Gonesse, le 15/03/2019.

**INFO-TECH CITROËN Racing C3R5 19-04**
**Sujet : Patch de Padding Va**
**Subject: Padding Va patch**

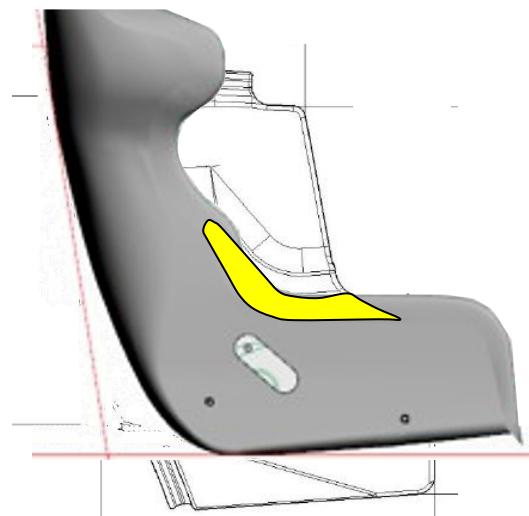
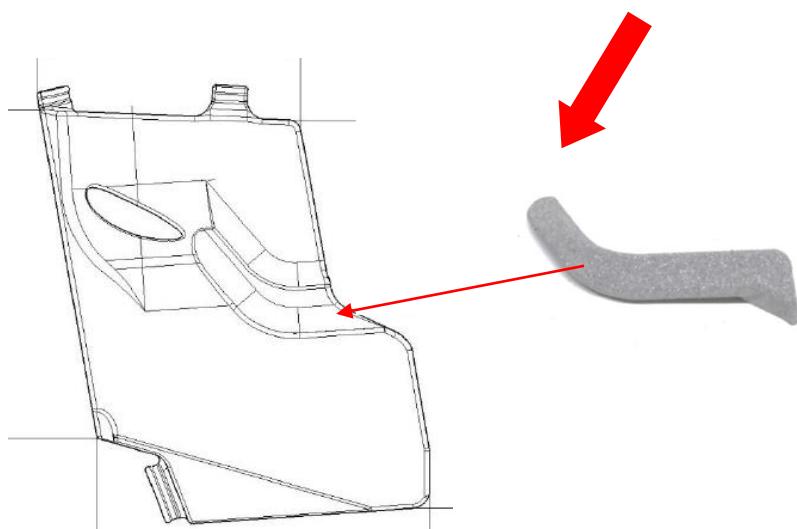
Position de siège pour laquelle le patch Va n'est pas nécessaire  
(la surface en jaune, n'a pas de vis-à-vis avec le baquet)

Position de siège (relevé et avancé) pour laquelle le patch Va est nécessaire (la surface en jaune, est recouverte par le baquet)

Dans le cas où vous devriez mettre le patch Va en place, veuillez utiliser la colle Bison Tix.

En cas de position médiane, nous vous conseillons, dans la mesure où cela ne gêne pas les mouvements du pilote d'installer ce patch.

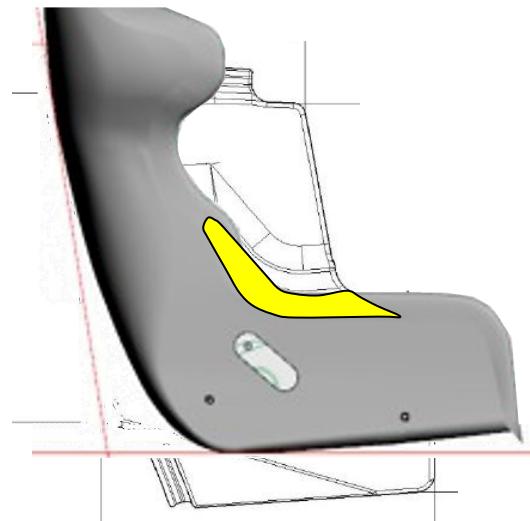
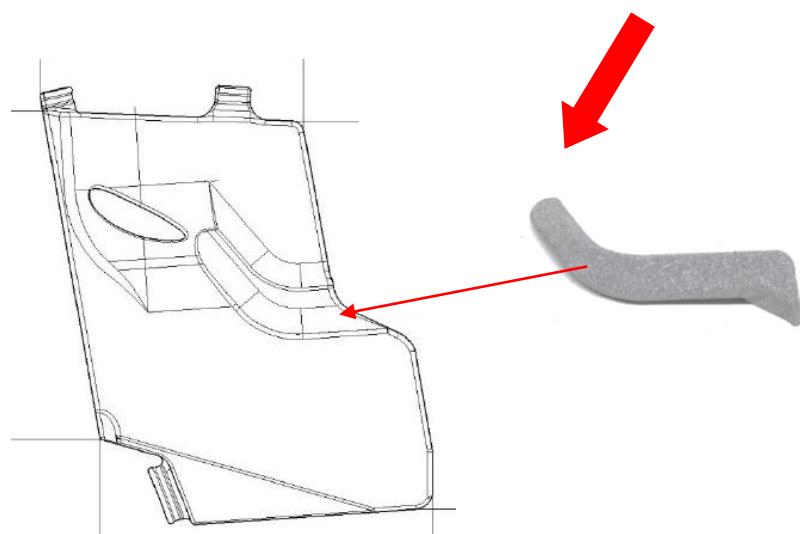
Seat position which do not need Va patch  
(the yellow area is not "covered" by the seat)

Seat position (high and forward) which needs Va patch  
(the yellow area is "covered" by the seat)

In case you need to fit the Va patch, this needs to be done with the glue Bison Tix.

In case of intermediate position, we advise you, if this doesn't prevent driver's movements to fit the Va patch.
